# Belmont Public Library

Library Building Committee Meeting #2  
January 17, 2023

## **Design Update Agenda**

Ground Floor Plan

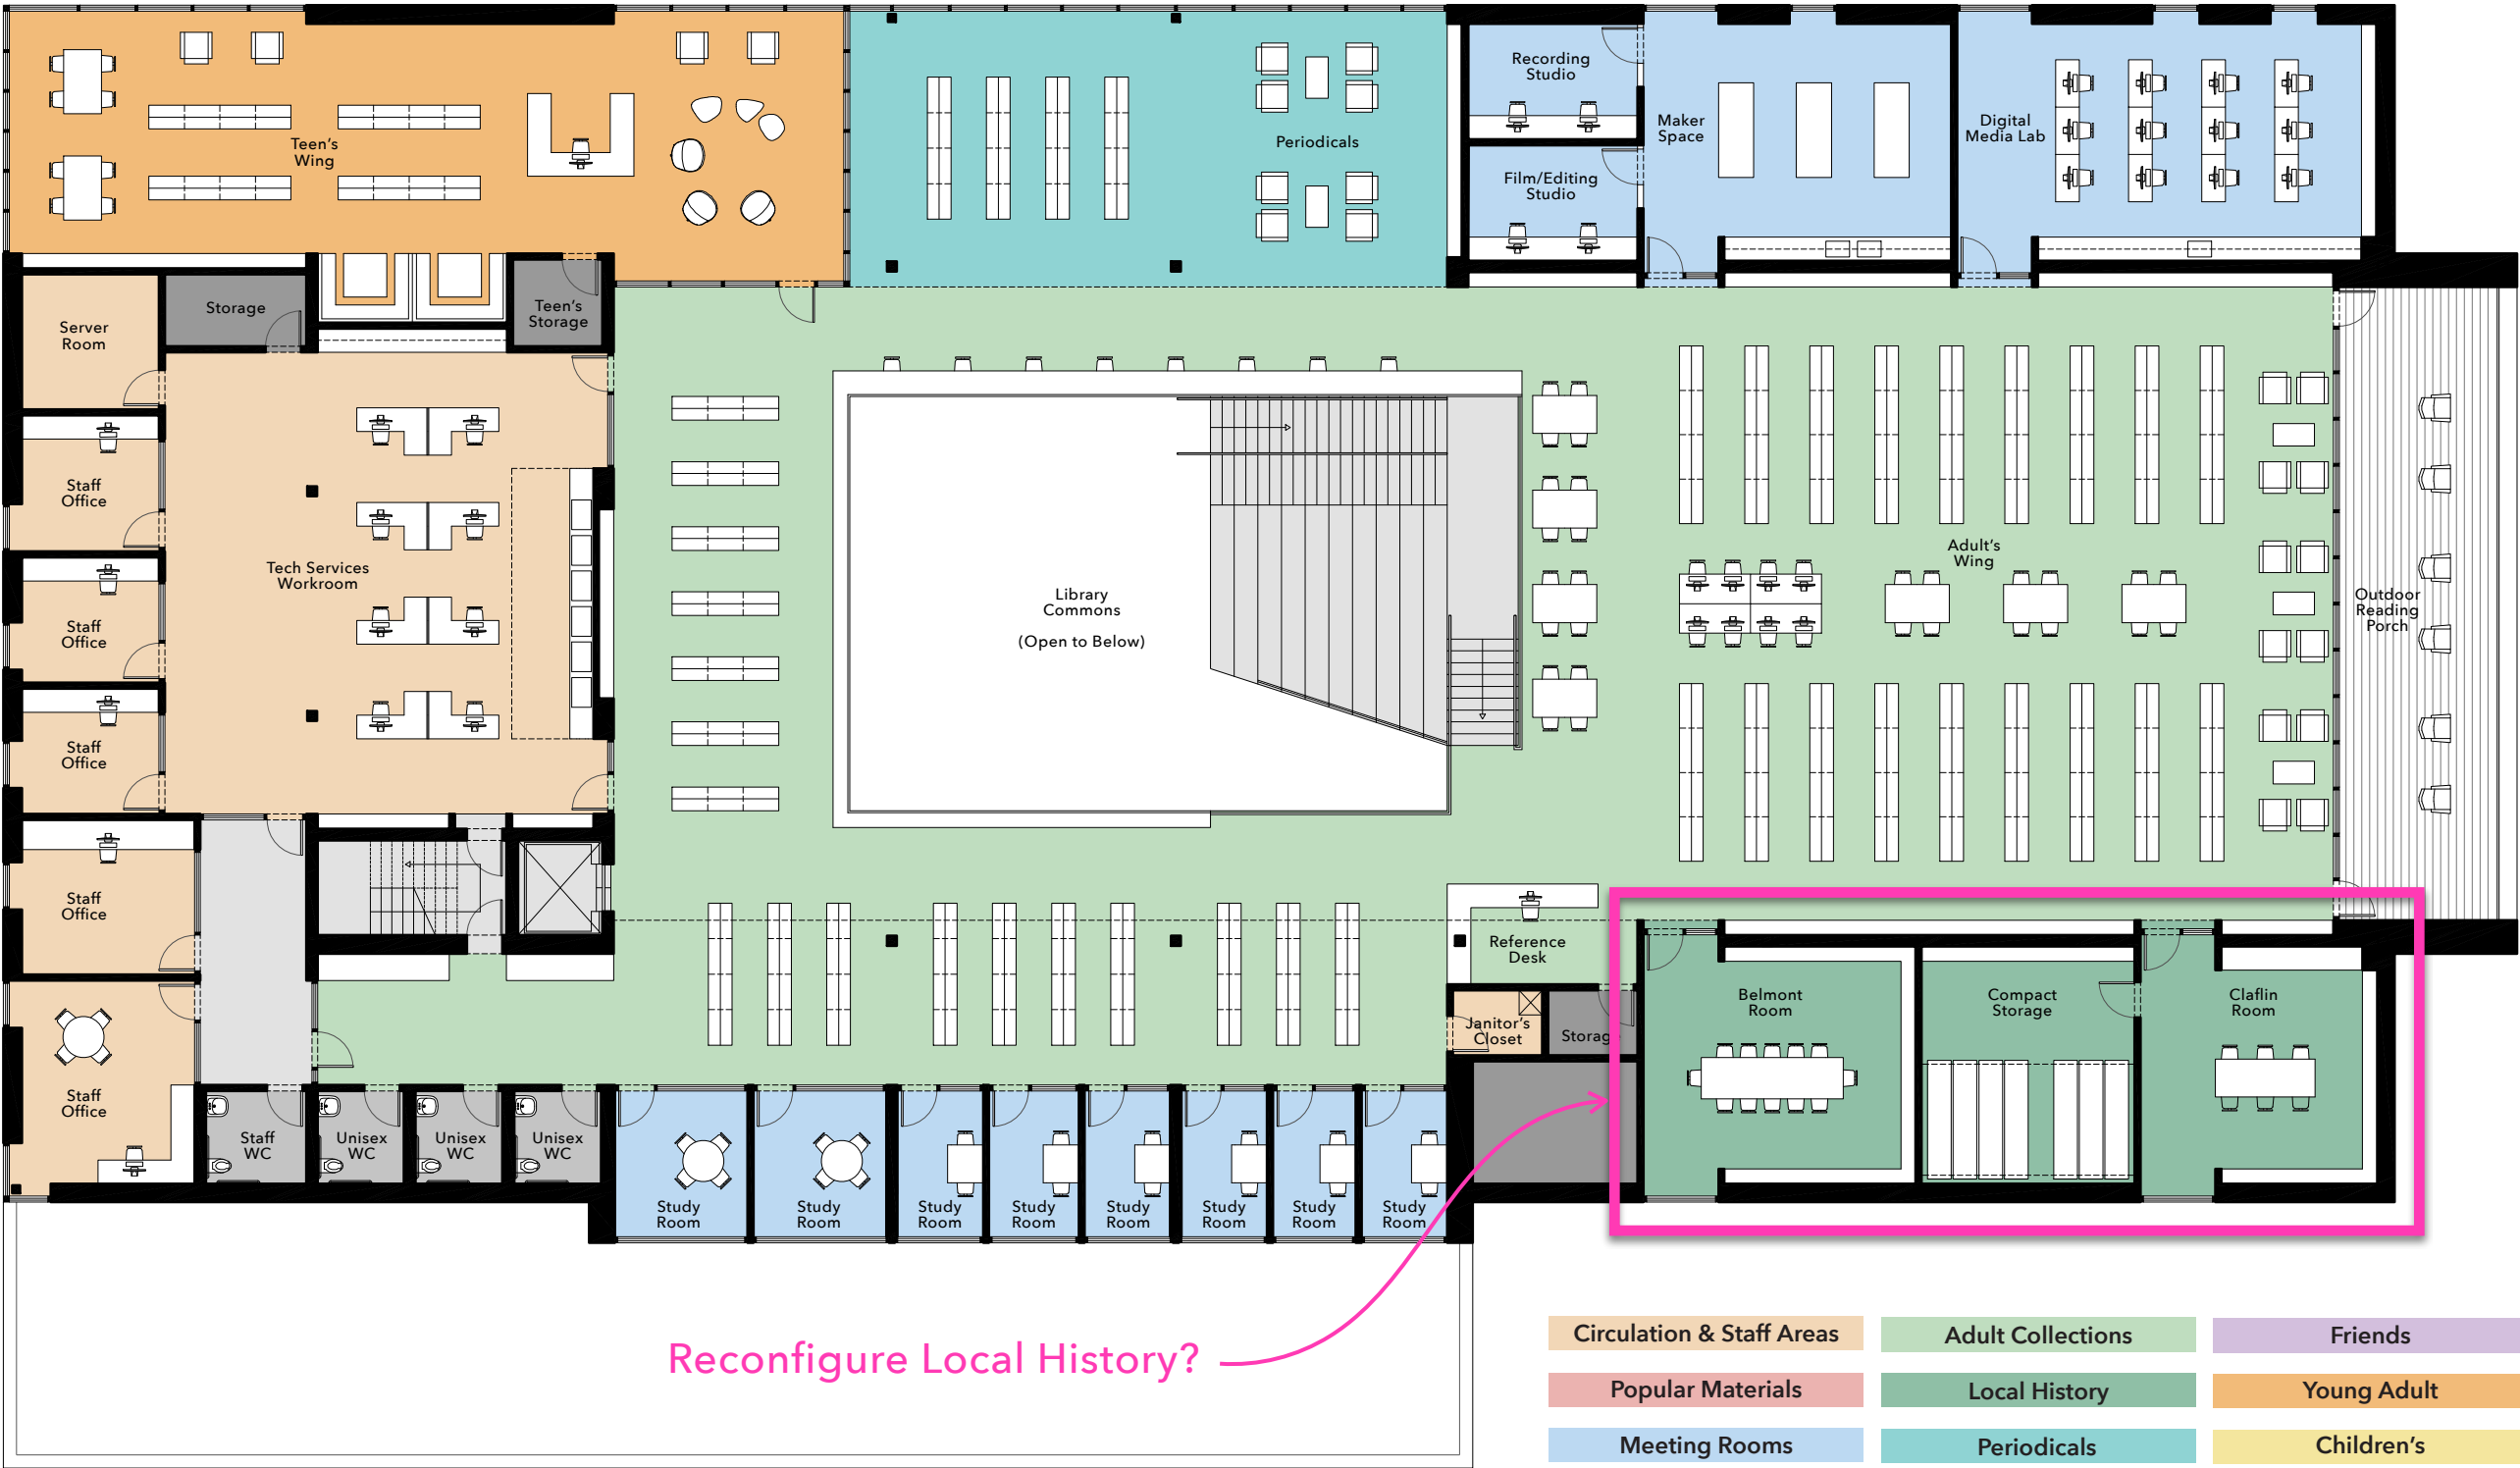
- Building has too much glass. Concerns about cost, maintenance, glare and heating/cooling loads.
- Commons stair is wasteful. There are accessibility and safety challenges if it is a primary stair and seating area.

- Need an accessibility review with experts and the Belmont Disability Access Commission.
- Building and site should be designed for true accessibility not just code/regulatory minimums.
- Commons stair is not accessible as a seating/gathering place. Can it be made accessible?
- Is one elevator sufficient? Suggest having two, also a glass lift at the Commons stair.

Revise Stair?
